**Power System Operation Corporation Limited
New Delhi**

Sub: Comments on behalf of Regional Load Despatch Centres (RLDCs) and National Load Despatch Centre (NLDC) on the Consultation Paper on Terms and Conditions of Tariff Regulations for the period 1st April 2019 to 31st March 2024

Fig 1 : Day Ahead Market (DAM) Unconstrained Market Clearing Price (UMCP) duration curve

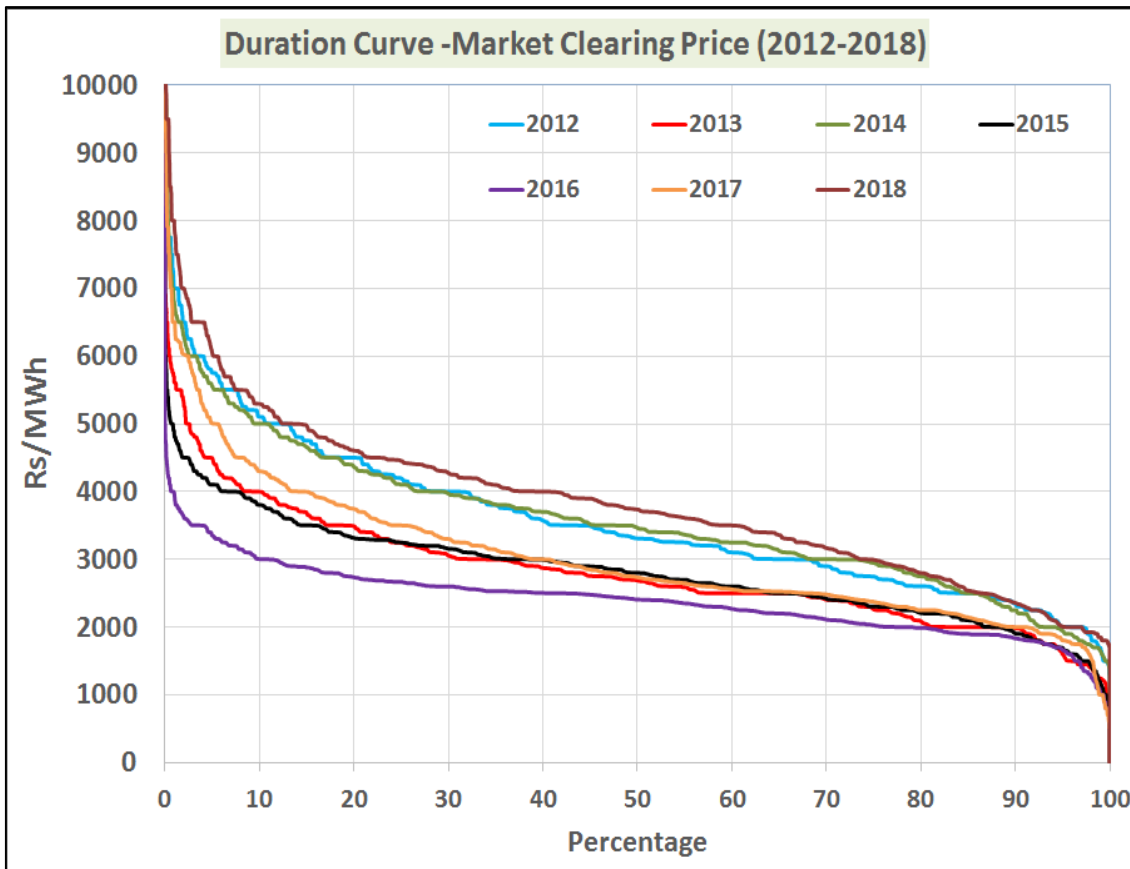
Fig 1 below indicates the price duration curve in the Day Ahead Market (DAM) for six years. If we look at a sample year, say 2017, the DAM prices have stayed above Rs. 3 per unit for more than 50% of the time. Thus a thermal power plant with variable cost of the order of Rs. 2.50 per unit would be able to recover part of its fixed cost for more than 50% of the time through the DAM. This along with the suggestions given in section 7.2.5 and section 10.3 could be formulated as indicated below.

A 1000 MW coal fired power plant could have an ACC for 700 MW (a minimum percentage could be defined by CERC) based on the requests of different beneficiaries. For this 700 MW, the power plant would be admissible for recovery of Fixed Charges and Variable Charges based on availability (section 7.2.5 of the consultation paper) as well as energy charges based on despatch.

For the balance 300 MW, the generator should be free to participate in the Day Ahead Market and earn the market based return. This would serve the interests of both the generator as well as the beneficiaries as the latter would be spared the burden of fixed cost for the 300 MW in the given example while the generator could get a market based return for the 300 MW. In the long run, the Annual Contracted Capacity (ACC) could be converted suitably to Contracts for Differences (CfD) leaving the entire 700 MW supply to be bid into the DAM.

Fig 2: Declared Capability, Schedule and Actual generation for a sample ISGS

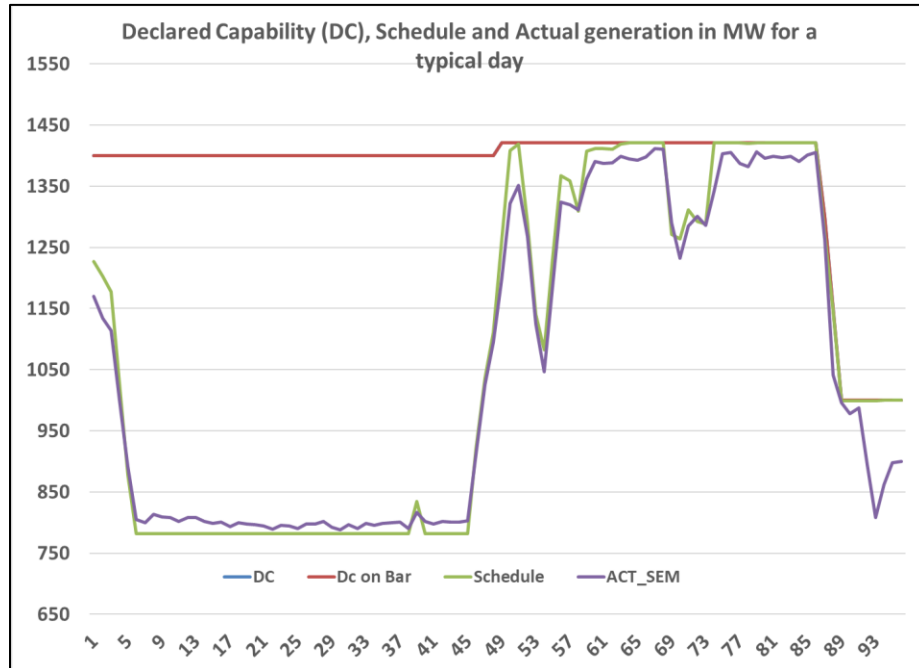
It has been observed during real time operation that generators are declaring full availability for the day but not maintaining enough fuel stock as required under the regulations. This becomes evident during periods of continuous high demand where they are not able to generate on sustained basis up to the DC values as illustrated in Fig 2 below for a typical Inter State Generating Station (ISGS).

Therefore, it is proposed that generators declare weekly availability depending on the fuel stock position in addition to the day ahead availability. The weekly availability should factor the fuel stock as well as the anticipated daily fuel receipts as well as fuel consumption. A suitable weightage (say 20%) may be given to this weekly availability figure and the day ahead availability (say 80%) for working out the plant availability. A monthly certificate from auditor in this regard may be made mandatory for fixed charge recovery. This will ensure security and reliability of power supply for DISCOMs. In case of gas power stations where there is no provision of gas storage, any reduction in DC as illustrated above should invite penal consequences such as reduction of availability for the last ten (10) days for every such instance reported by RLDCs.

Fig 3: Declared Capability (DC) and schedule in MW for Auraiya power station

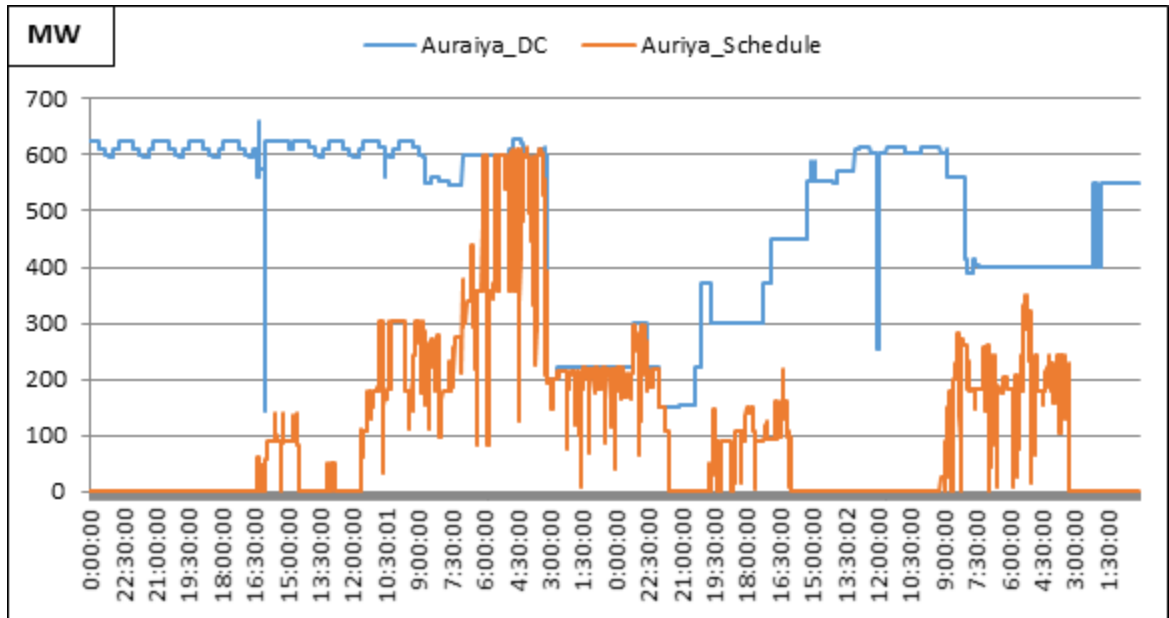
The generation output plots of Auraiya Gas for the month of September 2017 is provided in Fig 3 below for kind reference. Here it can be observed that as generation was scheduled as per the availability, the DC declared started coming down over the month.

The above behavior is within the regulations which specify the day ahead availability declaration and opportunity to revise the same in the course of the day. It raises a false sense of comfort on the generation availability front. The comfort turns into a surprise when the plant actually starts getting despatched and is unable to sustain the high generation level for more than a day and reduces the declared availability.

Fig 1 : Monthwise Availability of Elements under NLDC jurisdiction in Year 2016-17

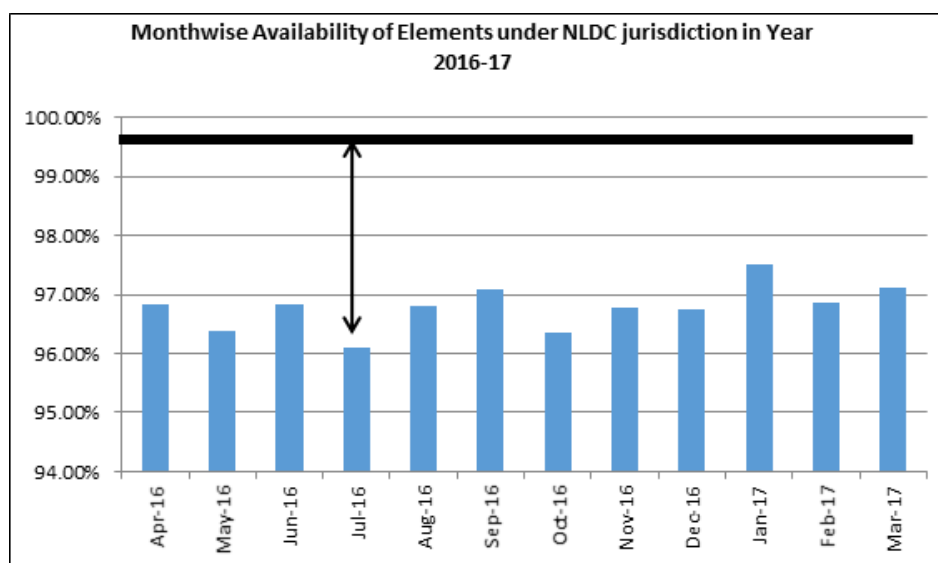
- Operational Vs Deemed availability:** NLDC records the outage of elements under NLDC Jurisdiction on monthly basis which simply calculates the time when element is under outage. The month wise plot for the FY 2016-17 is plotted below in bar chart. The duration calculated in NLDC calculation gives an idea of time when element was actually available, however it has been observed that the final availability after approval from RPCs becomes much higher. Major transmission licensee, in its annual report mentions availability of 99.79%(shown as horizontal dark line) for FY 2016-17, which makes licensee eligible for incentive apart from receiving fixed charge. This becomes important to mention that difference between operational availability and actual availability is wide (shown by vertical arrow). The difference is on account of the relaxation provided under different heads, for reliable operation of the system, this difference needs to be minimized.

In 2014-19 regulations lot of provisions exist for complementing reliability. However, the provisions for excluding outage hours attributable to the transmission licensee give lot of scope for circumventing the provisions. The lacuna in information dissemination by Regional Power Committees (RPCs) further compounds this problem. Transparency can be achieved by timely publishing of information by RPCs on their respective websites. The areas where scope of improvement is there are provided below:
